ENGINEERING INVESTIGATION REPORT  
ON  
LOSS OF THE SEACON'S CENTER WELL DOORS

FPO-1-80(2)  
DECEMBER 1979

OCEAN ENGINEERING  
AND CONSTRUCTION PROJECT OFFICE  
CHESAPEAKE DIVISION  
NAVAL FACILITIES ENGINEERING COMMAND  
WASHINGTON, D.C. 20374

SK-01 CENTER WELL DOOR HINGES

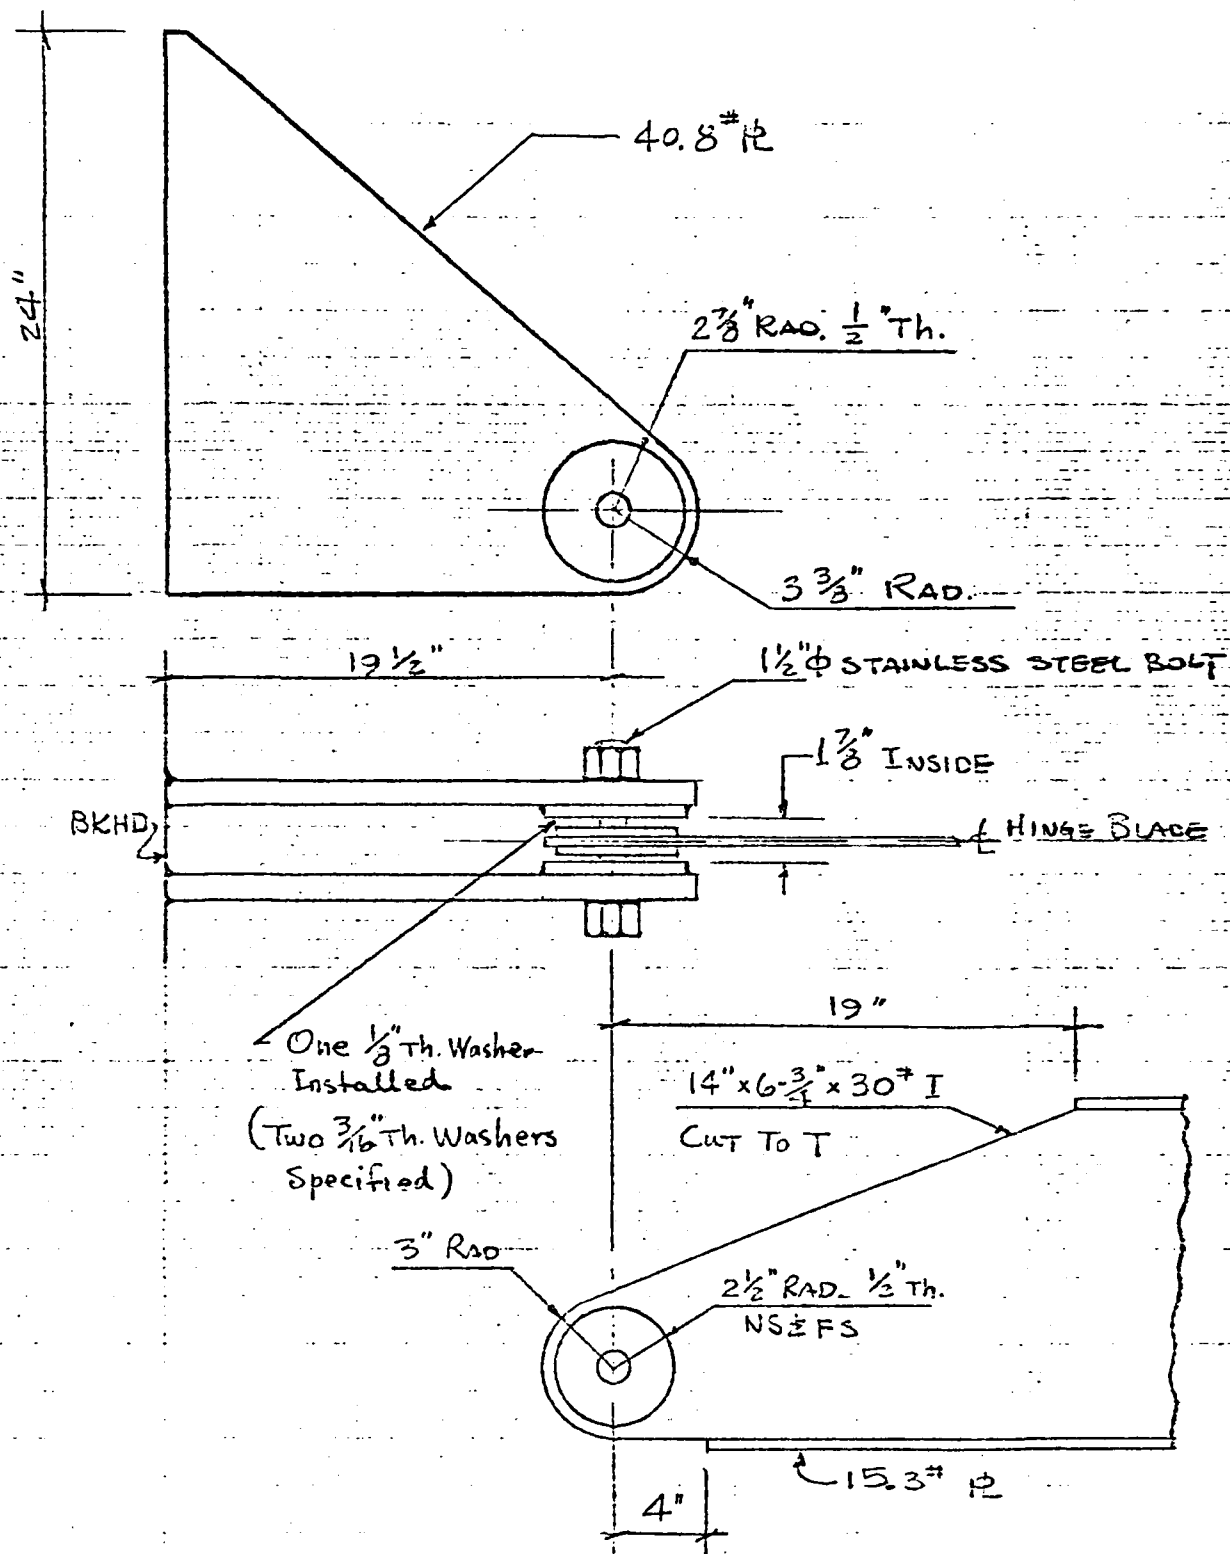
4.1 Door Design: The door design was found to be structurally sound except for members which formed part of the door-hinges. Two 14" deep beams run longitudinally as stiffeners. These are spaced 1/3 of the door-width apart; and a portion of the web of each beam extends to form a door-hinge-blade as shown by the sketch SK-01. The beams are adequate as stiffeners; but the 1/4" web does not provide adequate material for this particular design application of a hinge.

4.2 Hinge Design: SK-01 shows some of the critical details of the hinge assembly design. The two hinge-blades welded to the bulkheads and lower sill of the well are large pieces of 1" plate which are well supported by the ship structure. On the other hand, there is only one door hinge-blade per assembly; and it is only 1/4" thick. The design provides a poor balance in both strength and stiffness between the bulkhead hinge and the door hinge blades. It provides an equal disparity between vertical load capacity of the hinge assembly and the side-load capacity of the door hinge-blade. This latter deficiency fails to accommodate side-loads on the door caused by ship roll, yaw and sway; yet no other provision was made for taking such loads at the hinge-ends of the two doors. The inability of the hold down mechanisms, at the opposite end of the doors, to help alleviate this is discussed below. These hinge elements accumulated several million cycles of side load in the period between 1976 and the present. The condition exists whether the doors are in the up position, or in the down position. Even though this did not result in any noticeable permanent-set bending of the blades, they were certainly exposed to cyclic loads that under a combination of conditions could (and did) cause the failure of the door hinges. This design deficiency could only be aggravated by the omission of the spacer washers by the shipyard. Thus an increment of cyclic shock loading was added to the cyclic flexural loading on the hinge assembly (and the door hinge-blade in particular). The designer either overlooked this side loading condition, or he assumed that the hold down mechanisms at the opposite end of the doors would prevent side motion of the doors and side-loading of the hinge blades. In any case, the brilliance of hindsight shows that he was wrong in selecting this hinge configuration.

6.1 Door Hinges: The door hinge design is changed to a journal and bearing design so as to provide a thrust bearing to restrain side motion of the doors and to eliminate the improper use of blade-flexure to accomplish this function. This is done by replacing the 3" x 5" angle iron at the hinge edge of the door with a thick walled section of 4.5" O.D. pipe as shown in SK-04 and SK-05. The section modulus of this pipe is more than enough greater than that of the 3 x 5 angle which it replaces to compensate for the fact that the bending moment on the door (with the hinges outboard of the door) is greater than it was with the blade-hinges at the one-third spacing. The hinge journals are slideably disposed inside of the pipe leading edge of the door to provide for side-play adjustment and for installation/removal of the doors. SK-06 shows interface of the pipe-structure with the original design details of the longitudinal beams and the 3 x 5 framing around the door. Except for the piping leading edge, there are essentially no other changes in the door design. SK-07 shows the journal bearing design. The design transfers the bearing loads suitably into the side-wall structure of the well; and it provides bronze brushings with lubrication tubing accessible from deck level for servicing. This design eliminates the flexural fatigue problem and controls side-play so that door motion cannot cause escape from the door-sills at the hinge ends. It involves minimum changes in the door design; and it can be installed and fitted up by use of cofferdam.

SK-02 DOOR SILL INTERFACE

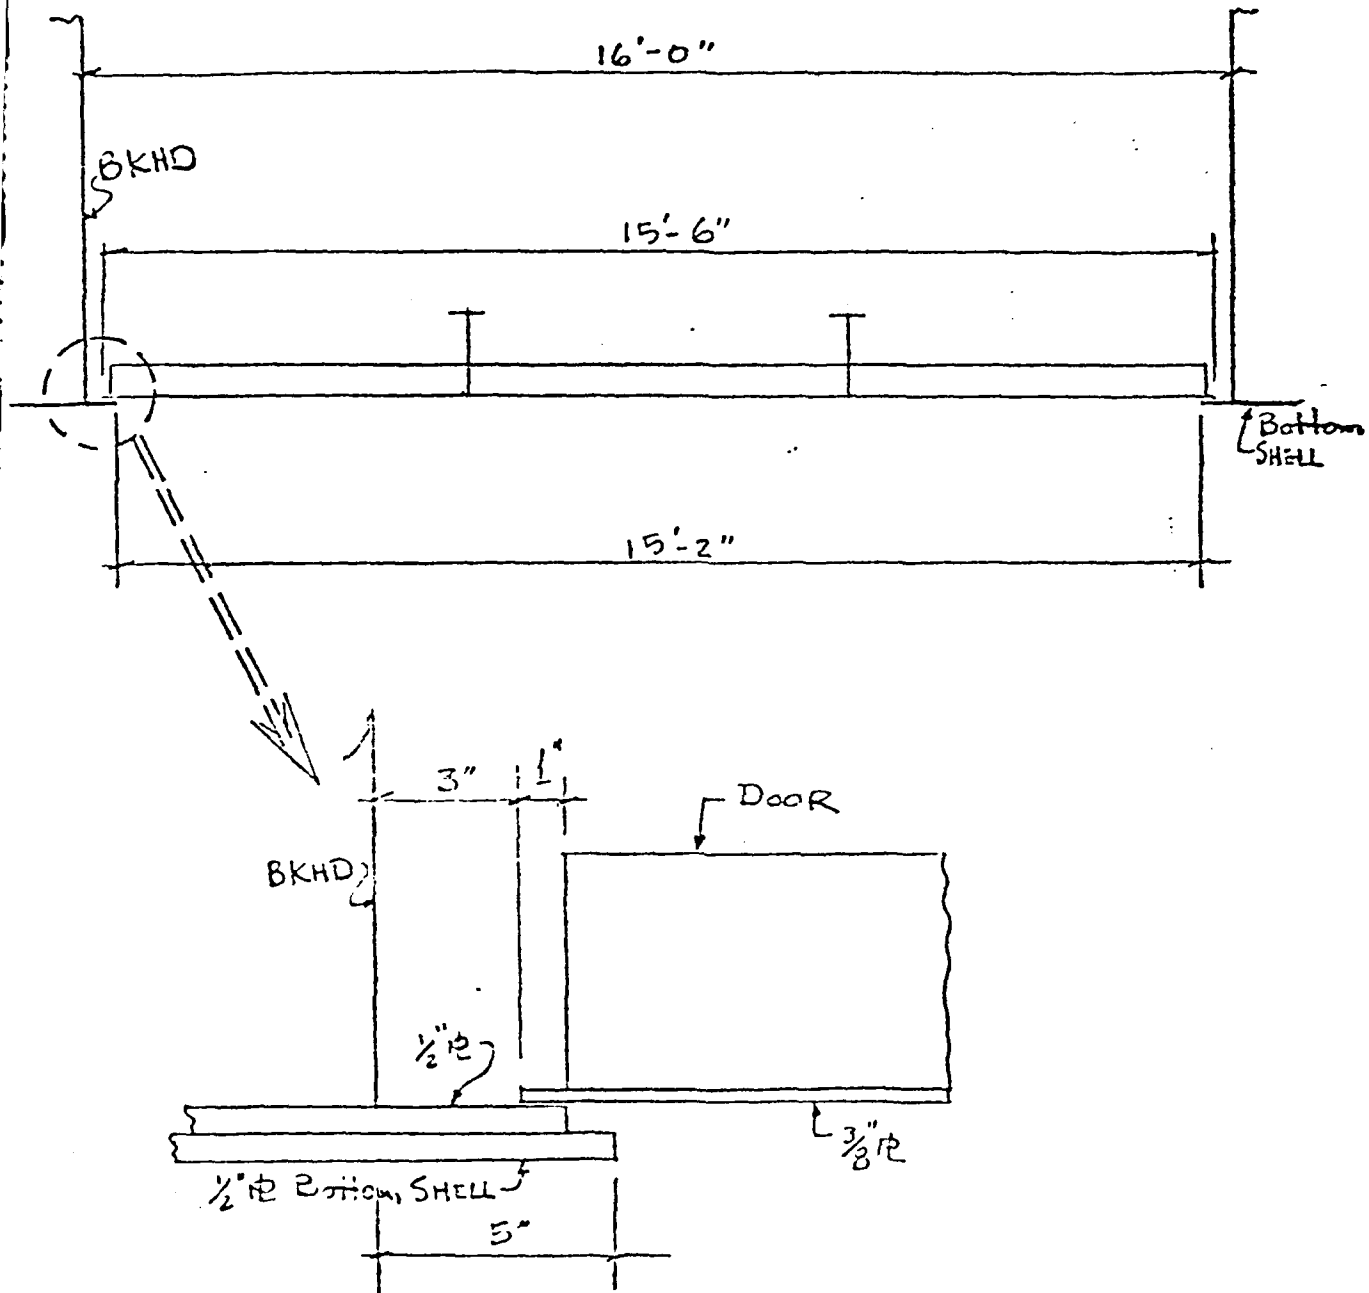
4.3 Door Sill Design: SK-02 shows the interface of the doors and the door side-sills based on nominal dimensions. It can be seen that if the side motion of the doors is not restrained by the hinges at one end, and the hold down mechanisms at the other, the door can escape the door sill and fall out. Note: there is no overlap between the doors and the fore and aft "sills". Thus the failure of the door hinges at one end, and

inability of the hold downs to prevent side motion at the other end, can permit a door to drop out of the well (and it did). It should also be noticed that the bearing between the door and the sill is greatly weakened by the 1" setback between the doublers and the shell plating on the two parts. Also note that this discussion is without any consideration as to the unknown tolerances and fit-up of the ship and the doors.

6.2 Door Sills: The original door sills were found deficient in design and were so battered up that they had to be straightened and/or replaced. Considering the difficulties involved and the availability of the cofferdam, it was recommended that the side-sills be cut away and replaced with a heavy-wall 6 x 6 angle iron section as shown in SK-08. By raising the angle base leg up about 1/2", the welding can seal the crack between the shell-plate and the doubler, as well as weld the heel of the angle iron to the sidewall of the center well. Since a substantial discontinuity already existed between the shell plating and the under-surface of the doors, an additional 1/2" or so was of no matter. Considering all of the ventilation holes in the doors, and the large gaps at their foreward, middle and aft edges, the doors were obviously only effective as surge-dampers and were not intended to be even approximately flush with the ship plating for hydrodynamic reasons. This

recommendation provided a practical means to repair the damaged door sills and to improve the design deficiency by eliminating the underlap that permitted escape of the doors from the sills.

SK-03 FOREWARD DOOR FALL-OUT

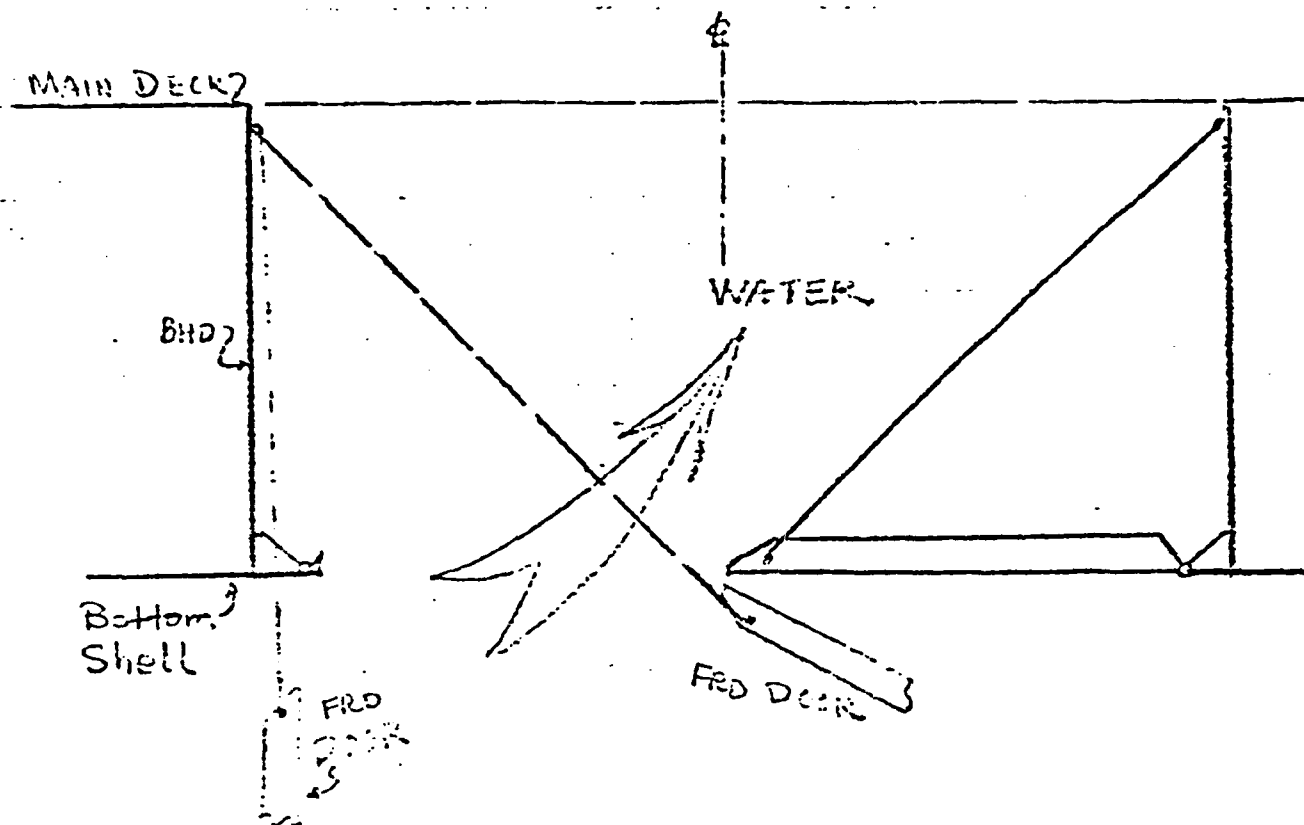
5.1 Loss of Forward Door: The door hinge-blades of both doors had suffered progressive deterioration due to cyclic side loads during past operations; so that while under tow in fairly high following seas the foreward door hinge blades broke off. The hold downs did not have sufficient clamping power to restrain the side loads on the hinges; and when the hinges broke, the clamping action was not sufficient to restrain the door from sliding sidewise, escaping the sills and falling out of the well. The falling door was restrained by its' two lift cables and brought up against the leading edge of the aft door as shown in SK-03. Here the two lift cables were abraded and broken away and the door was released and lost.

SK-09 JACK SCREW HOLD DOWN ASSEMBLY

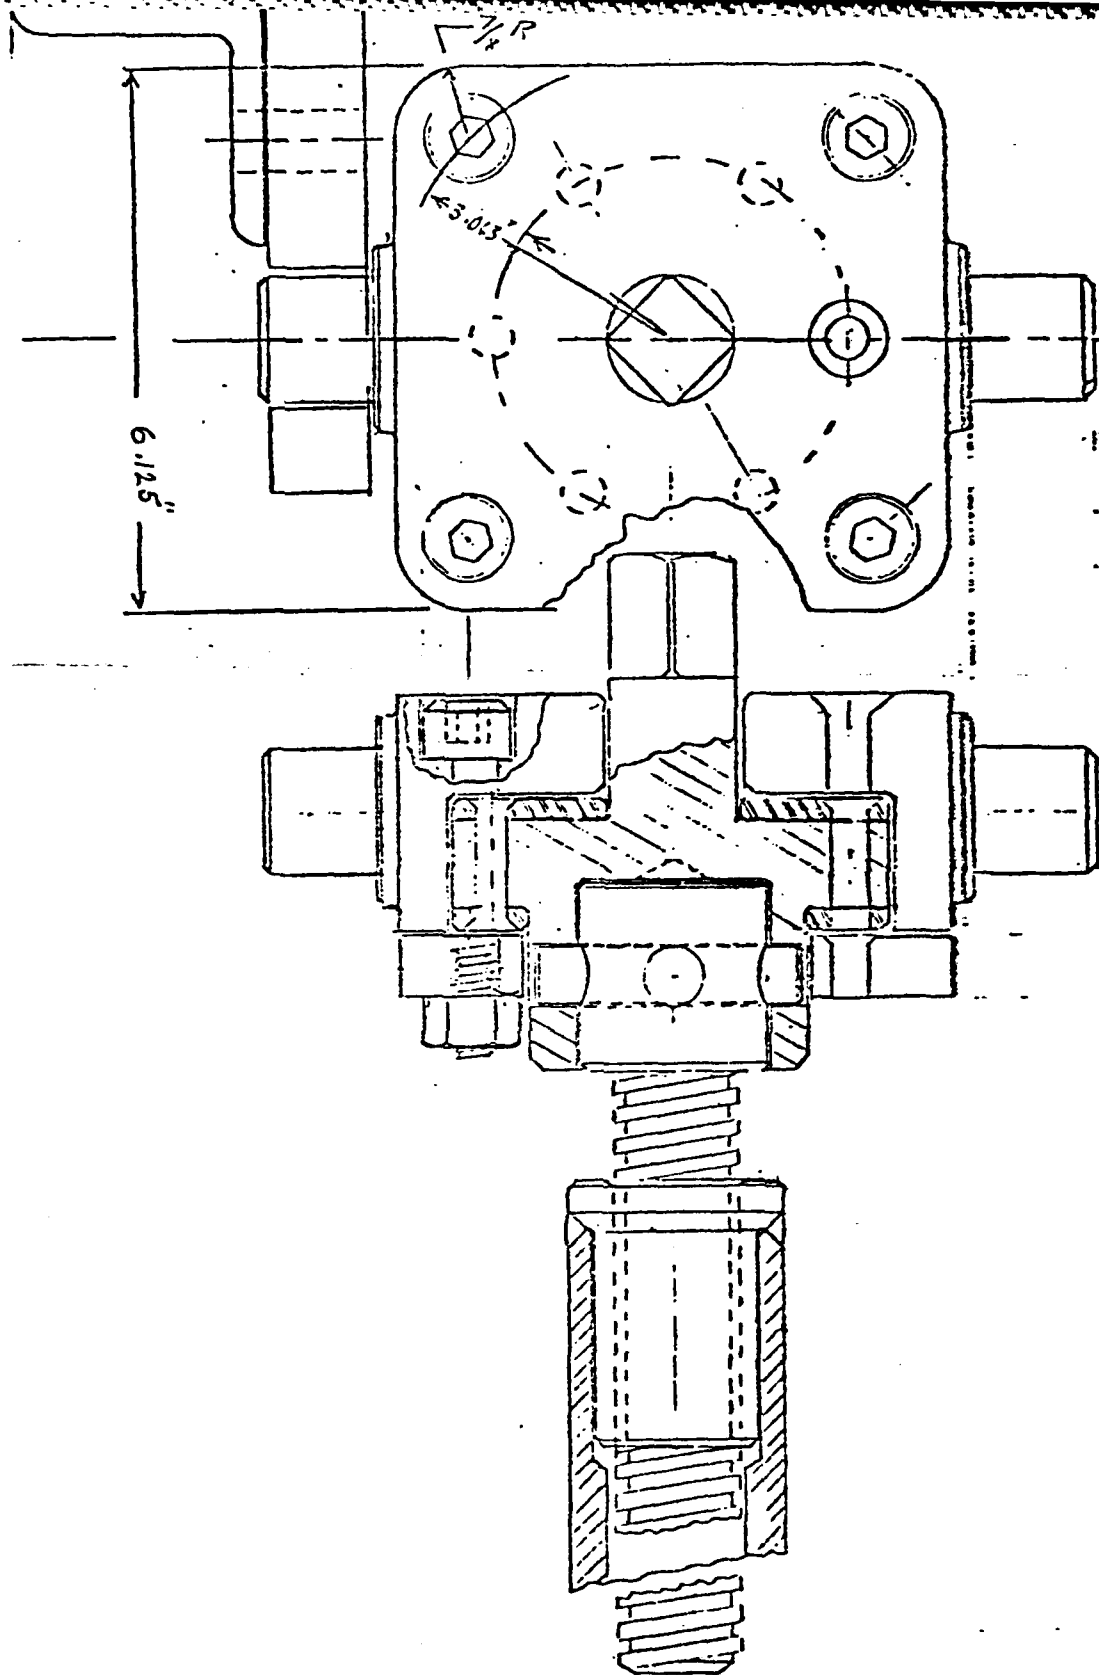
4.4 Hold Down Mechanism Design: Forces to hold the doors in the down position were applied to the corners of the doors opposite to the hinges by four mechanisms. A spiral wedge-plate was mounted on the corner of the door. It could be engaged by a rotary dog which was fastened to a torque rod that reached up to nearly deck level. The crew applied drive - input torque to this rod by means of a large tee wrench. This input developed a vertical load on the door to hold it down on the door sill. The magnitude of the vertical load was function of the mechanical advantage of the wedge and the frictional torque restraint of the drive rod bearings and the dog-shoe on the wedge. It seems unlikely that crewmen would produce more than about 600 foot pounds of input torque at the tee wrench while standing on deck; and it is not likely that the friction coefficient of the dog on the wedge would be less than 0.1, nor greater than 0.5 under water with some ship vibration. Consequently with the mean radius of rotation for the dog-shoe of 0.5 feet, the vertical hold down force would be in the range of 2,400 -- 12,000 pounds per mechanism. This force is in the same order of magnitude as the distributed gravity force of a door. It is not in itself significant since the thrust bearings on the dog-shoe provide the ultimate hold down function for the doors. The interesting point is that this magnitude of bias force cannot generate the frictional resistance of the doors on the sills to resist side motion (when ship vibration, hydrodynamic turbulence of flow over the ship bottom and vertical surge forces through the door vents are considered). Roll yaw and sway accelerations of a fraction of a "G" will cause side motion that such a frictional clamp cannot restrain. The hold down mechanism should be looked on therefore as a means for placing and retracting a door stop -- and not as a clamp capable of restraining side motion.

6.3 Hold Down Mechanism: The deficiencies in the design of these mechanisms were that they were not capable of providing enough added friction of the door against their sills to protect the hinge blades from flexural fatigue loading; the ability to provide vertical clamping of the door to the sill varied widely depending on friction between the hold-down shoe and the wedge on the door. Side motion of the door could twist and loosen the shoe and the torque shaft assembly. With the new hinge design, it is possible to come up with a new mechanism which is interchangeable with the old one. It is shown in SK-09 and SK-10. The element is above the water level in the well. It is provided with a lubrication accessible from deck level; and it uses a safety lock-pin which is not dependent on friction to maintain the up/down settings. The interface with the door is a rocker arm which is actuated by the jackscrew and strut mechanism. The cam-plate on the door could be designed to develop both vertical and side-motion resistance; however, the final decision was to use a flat plate for vertical resistant only. This eliminates the rollers on the rocker arms. Lubrication of the rocker arm assembly from the deck level is specified. Since the function of this mechanism is only to provide a remotely actuated hold-down vertical-stop, and because of its high mechanical efficiency, it is not necessary to try to brute force it into the down position. A sufficient force can be developed and controlled by use of a preset torque wrench; and any discrepancies between torque release and the jackscrew "down" position indicator will show that a malfunction exists.

6.4 Acceptance of Recommendations: The above engineering recommendations were presented to Mr. E. B. Spencer (FPO-1C, Director, Construction Division) and Mr. K. Egar and Mr. E. Clausner (Tracor) on 29 November 1979. They were accepted with the decisions to add the side-motion guide wedges, eliminate the horizontal restraint option of the rocker arm (and eliminate the need for the rocker arm rollers); and to make the jackscrew drive accessible through openings in the hatch covers.
